UNITED STATES PATENT AND TRADEMARK OFFICE

Office Action Summary

10/758,494

DETAILED ACTION

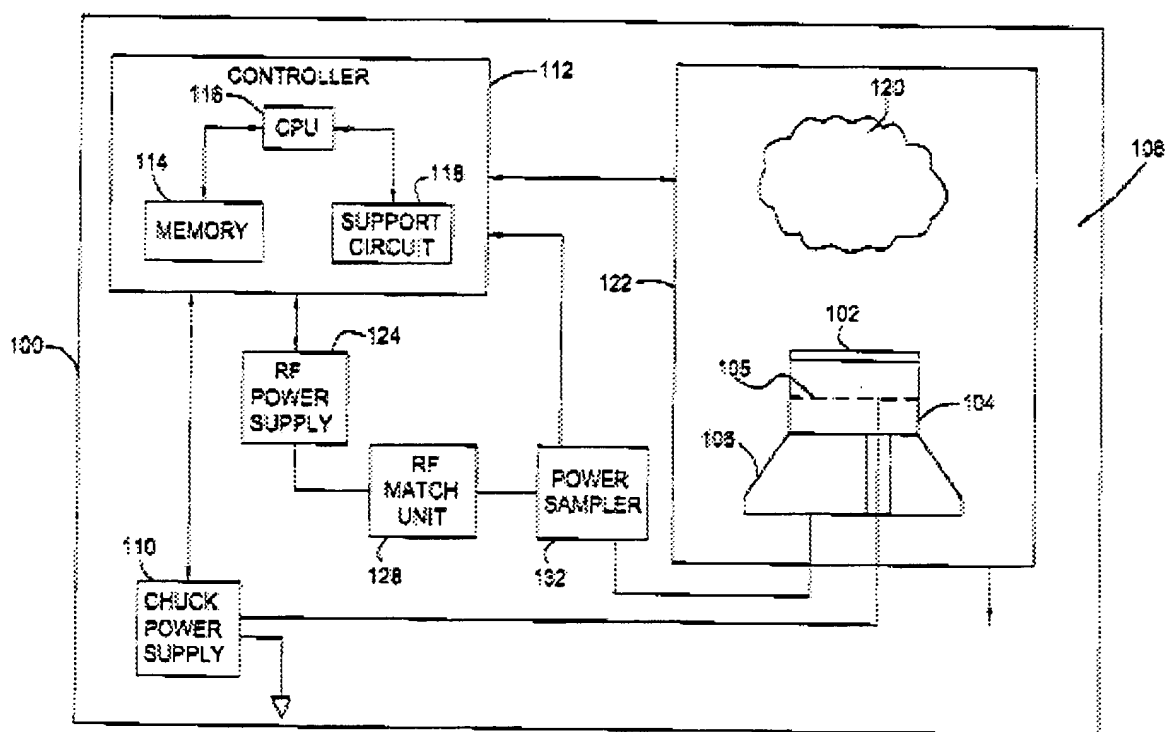
2. Shoji discloses a circuit substantially as claimed. Please see FIGS. 1-8 where Shoji teaches the

4. Pertaining to claim 1, Shoji teaches a circuit configured to interface with an etch tool, said circuit comprising:

an ESC input for receiving a first signal **132** from said etch tool (the etch tool in this case is the chuck **104**), said first signal indicating a magnitude of a chuck current passing through a chuck holding a wafer in said etch tool;

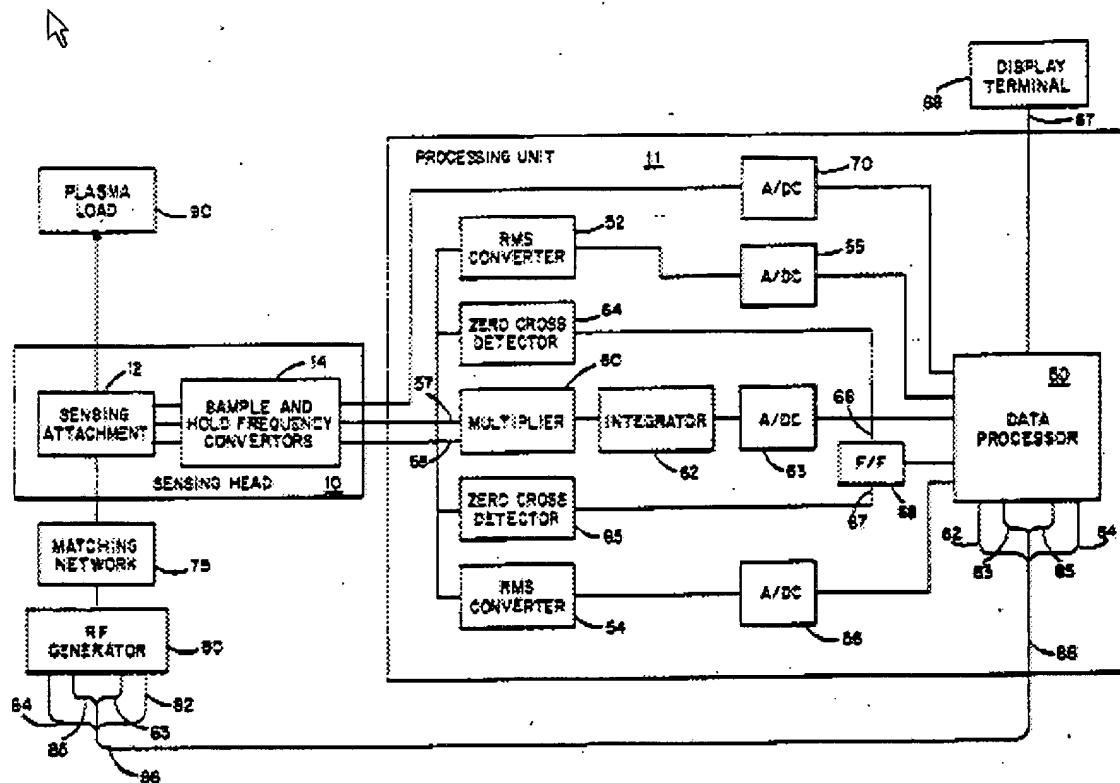
a VRF input for receiving a second signal from said etch tool, said second signal indicating a magnitude of a voltage difference between a plasma and said chuck in said etch tool;

an arc detect output **112** indicating whether an arc event has occurred, wherein said arc detect output does not indicate an occurrence of a chucking and a de-chucking spike in said etch tool.

However, Shoji does not specifically use the term “VRF input” for receiving a second signal from said etch tool. The Examiner takes the position that the VRF is equivalent to either the Sample and Hold Frequency converter **14** of Johnson or the A/DC 70, 55, 63 or 56.

See Johnson **FIG. 1**. In view of Johnson, it would have been obvious to one of ordinary skill in the art to incorporate the input receiving circuit into the Shoji circuit because RF power source can be maintained irrespective of impedance fluctuations (see Abstract). Please note that all circuits fail in which no output is obtained, see response to arguments above.
